Section 33.7 Loss of management frame communication

Section 33.7.1 PSE loss of communication

Add the following variables to section 33.6.6.2

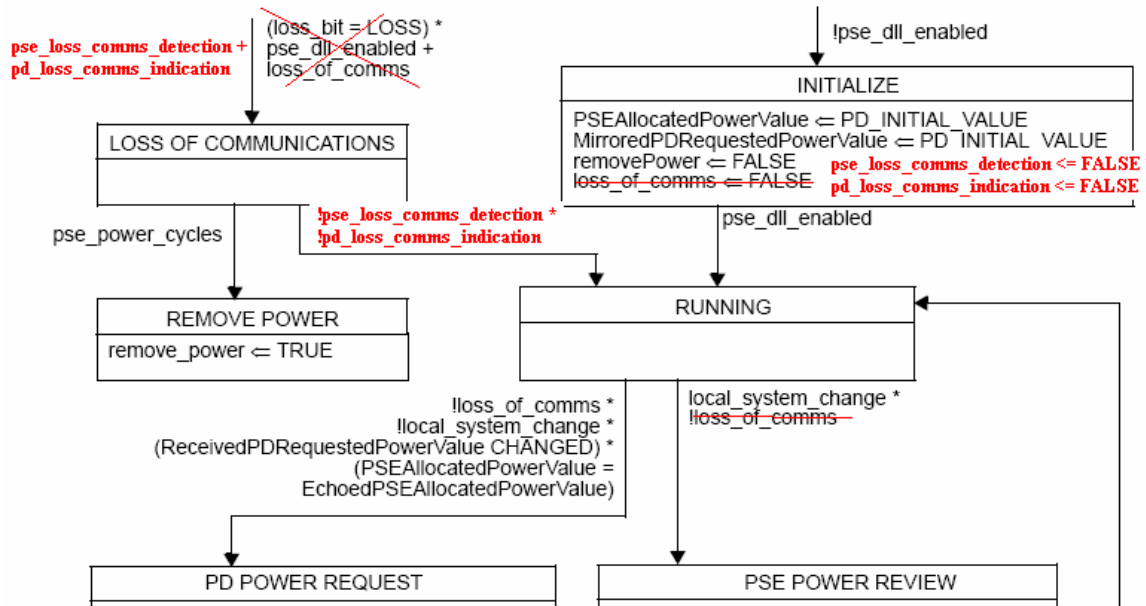
Remove the variable loss_of_comms

pse_loss_comms_detection
This variable maps into the aLostCommunication attribute (30.9.1.1.21).
Values: TRUE: Loss of communication as defined in 33.7.1 has occurred in the PSE local system
FALSE: Loss of communication as defined in 33.7.1 has not occurred in the PSE local system

pd_loss_comms_indication
This variable is mapped from the aMirroredLostCommunication attribute (30.9.1.1.22).
Values: TRUE: Loss of communication as defined in 33.7.2 is asserted by the remote system and gets mirrored to the PSE local system
FALSE: Loss of communication as defined in 33.7.2 has not occurred in the remote system

pd_loss_comms_detection
This variable maps into the aLostCommunication attribute (30.9.2.1.11).
Values: TRUE: Loss of communication as defined in 33.7.2 has occurred in the PD local system
FALSE: Loss of communication as defined in 33.7.2 has not occurred in the PD local system
